UNITED STATES
DEPARTMENT OF THE INTERIOR
BUREAU OF LAND MANAGEMENTFORM APPROVED
OMB NO. 1004-0137
Expires: January 31, 2018**SUNDRY NOTICES AND REPORTS ON WELLS**
Do not use this form for proposals to drill or to re-enter an abandoned well. Use form 3160-3 (APD) for such proposals.5. Lease Serial No.
NMNM0506A

☐ Oil Well ☒ Gas Well ☐ Other8. Well Name and No.
POKER LAKE UNIT 16 TWR 161H

XTO Permian Operating, LLC, requests permission to make the following changes to the original APD:

Poker Lake Unit 16 TWR 161H
 Projected TD: 23101' MD / 12709' TVD
 SHL: 492' FNL & 400' FWL , Section 21, T24S, R31E
 BHL: 200' FSL & 522' FWL , Section 28, T24S, R31E
 Eddy County, NM

Wellhead diagram during skidding operations

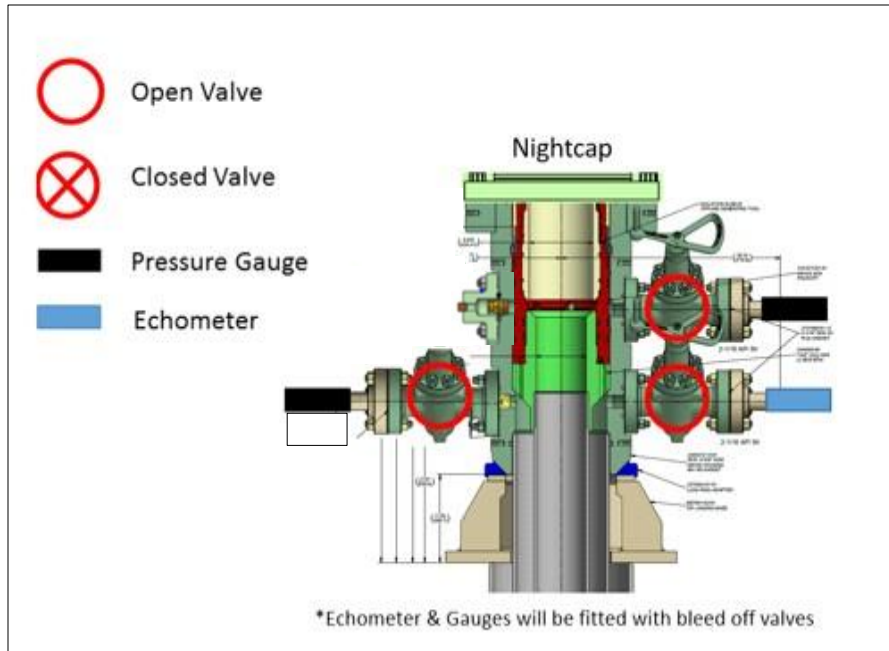
6. Skid rig to next well on pad.
7. Confirm well is static before removing cap flange, flange will not be removed and offline cementing operations will not commence until well is under control. If well is not static, casing outlet valves will provide access to both the casing ID and annulus. Rig or third party pump truck will kill well prior to cementing or nipping up for further remediation.

Wellhead diagram during offline cementing operations

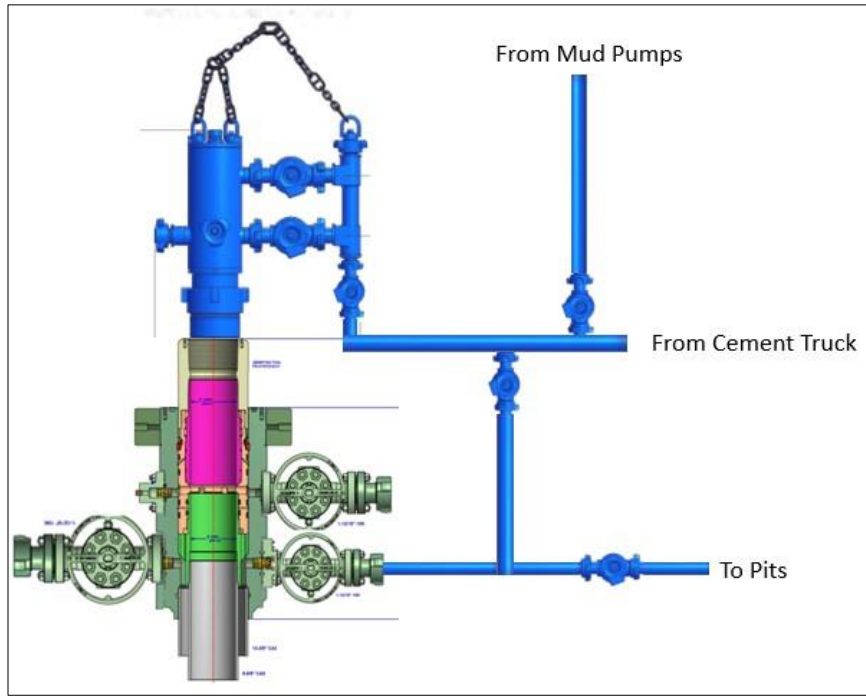
10. Circulate bottoms up with cement truck
 - a. If gas is present on bottoms up, well will be shut in and returns rerouted through gas buster to handle entrained gas
 - b. Max anticipated time before circulating with cement truck is 6 hrs
11. Perform cement job taking returns from the annulus wellhead valve
12. Confirm well is static and floats are holding after cement job
13. Remove cement equipment, offline cement tools and install night cap with pressure gauge for monitoring.
